SUBJECT: AMENDMENT OF SOURCE MATERIALS LICENSE SUA-1350 TO REMEDIATE
CATCHMENT BASIN CONTAMINATION AT THE KENNECOTT URANIUM
COMPANY'S SWEETWATER PROJECT, AMENDMENT 21 (TAC LU0073)

TECHNICAL EVALUATION REPORT FOR
KENNECOTT URANIUM COMPANY'S CATCHMENT BASIN REMEDIATION PLAN
FOR THE SWEETWATER URANIUM PROJECT

DATE: May 9, 2005

FACILITY: Sweetwater Uranium Project

FIGURE 1

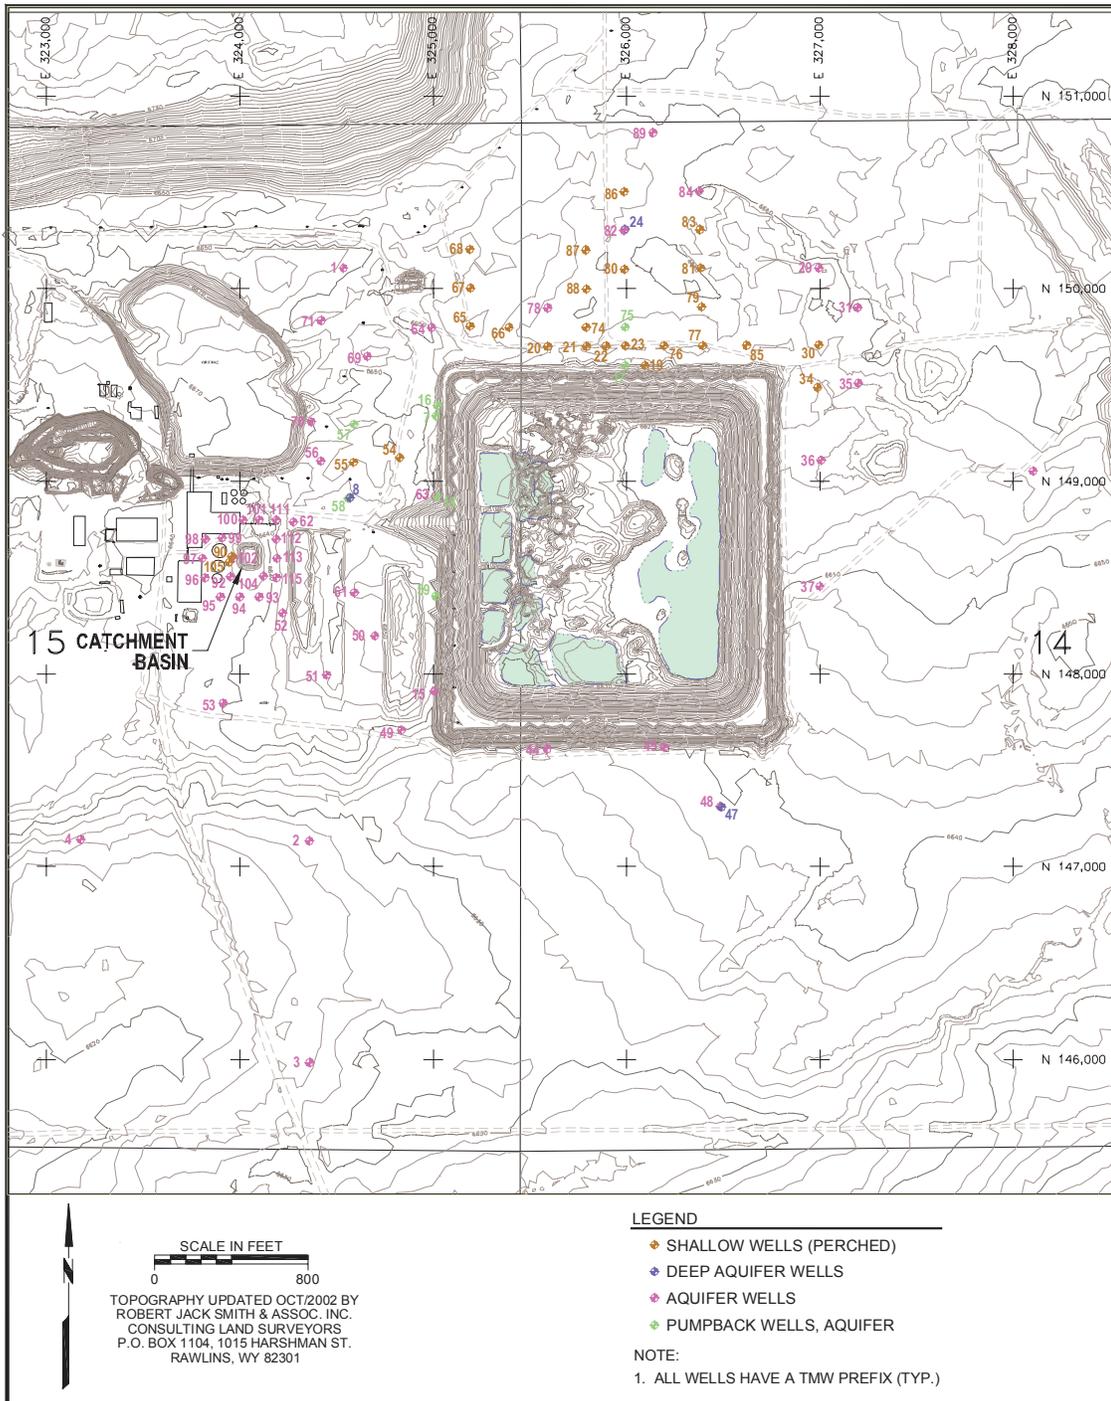
KUC's Sweetwater Uranium Project mill site is located in a remote area of south-central Wyoming, in Sweetwater County, approximately 42 miles northwest of Rawlins, Wyoming. The Sweetwater Uranium Project (Site), as defined by the NRC-licensed area, occupies approximately 445 ha (1,100 ac) and consists of a mill, ancillary buildings, existing tailings impoundment, and the area of proposed impoundments, evaporation ponds, and diversion channels. Bordering the Site is an overburden soil pile and a uranium ore pit (see Figure 1).

During mill operation upsets, fluids (11e.(2) byproduct material) from the counter-current decantation and solvent extraction process were placed in the catchment basin located between the mill buildings and the tailings impoundment (see Figure 2). This basin is approximately 42.7 meters (140 feet) square, 3.7 meters (12 feet) deep, and the bottom is approximately 19.8 meters (65 feet) square. Basin sides were lined with concrete while the bottom was unlined. Organics, metals, and radionuclides in these basin fluids slowly migrated through the soil beneath the basin and into the upper portion of the Battle Springs Aquifer at the Site. Primary contaminants are diesel range organics (DRO) and Ra-226; however, minor amounts of volatile organic compounds and metals (aluminum, iron, and manganese) are also present. Contamination was discovered in January 2003, and results of the preliminary investigation were documented in a letter to NRC dated October 15, 2003. As of March 2004, a total of 19 monitoring wells and 33 boreholes had been drilled.
